Re: TURKEY POINT UNITS 3 & 4
DOCKET NOS. 50-250 & 50-251
"ΔT vs. REACTOR POWER" CURVE

Re: TURKEY POINT UNITS 3 & 4
DOCKET NOS. 50-250 & 50-251
" ΔT vs. REACTOR POWER" CURVE

NRC "PRELIMINARY REVIEW" QUESTIONS

FPL RESPONSE TO NRC "PRELIMINARY REVIEW" QUESTIONS

PTP
CALORIMETRIC SECTION

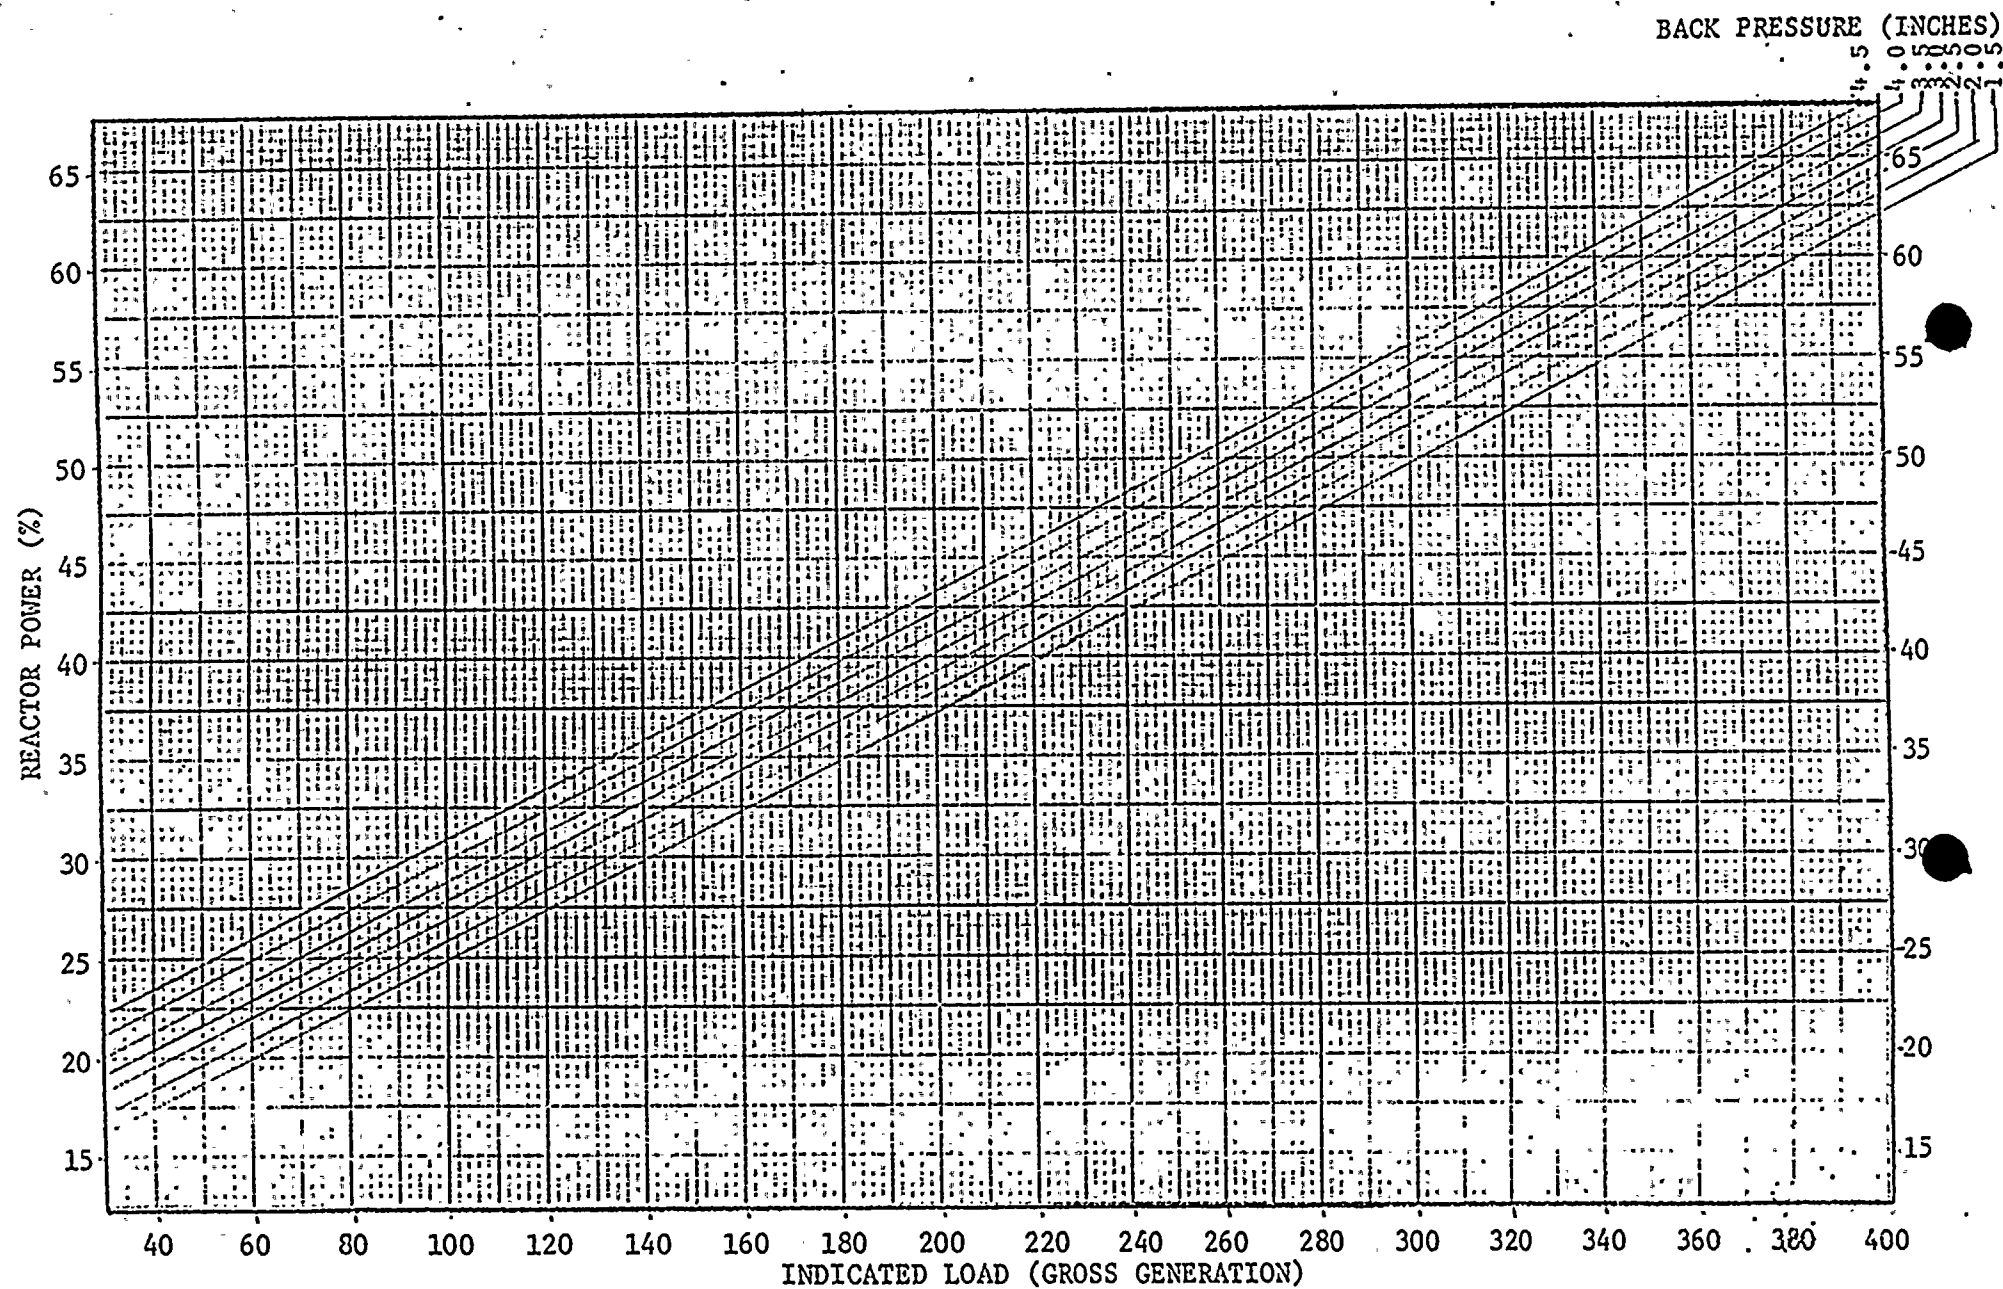
1. Describe, using sketches or drawings as necessary, all the instrumentation used in the existing load vs. flux method. Include channel accuracy, calibration frequency and overall curve accuracies. What section (s) of the FSAR covers this equipment?
2. Does the ΔT vs. power curve include flow rate?
3. Describe, using sketches or drawings as necessary, all the instrumentation used in the proposed ΔT vs. power method. Include channel accuracy, location of sensors, calibration frequency and overall curve accuracies. What section (s) of the FSAR covers this equipment?
4. Describe procedures and calculations used in both methods of this calibration check. Reference the written procedures and logs of this check.
5. List the qualifications of the instrumentation for the proposed ΔT vs. power method. Specifically, is it qualified as safety grade equipment?

Operating Procedure 12304.3, Power Range Nuclear Instrumentation Shift Checks and Daily Calibrations. Determine backpressure from the difference between barometric pressure and condenser vacuum or from the plant computer. Read reactor power as a function of backpressure and indicated generator load (see attached figures). The difference between calorimetric power and Flux Vs. Load Power is the correction factor for the shift.
